| TITLE: MOTORISED SLIDING GATE & FENCE | | | NIHVA TECHNOLOGY PVT. LTD. PUNE<br>Tel : 020 66304033<br>Email:- info@nihva.com<br>Website:- www.nihva.com |
| DRAWN | OMKAR | 28/11/16 | CLIENT - HYOSUNG T&D |
| APPROVAL | | | DWG. NO. : NIHVA/16-17/108/R01 |

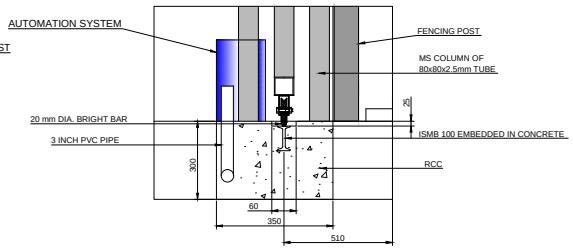
Revision - 1. Top of bright bar will be match with floor level. as ISMB100 will be 25mm below floor level.
2. Fencing will be modified with control panel position to have access with it.
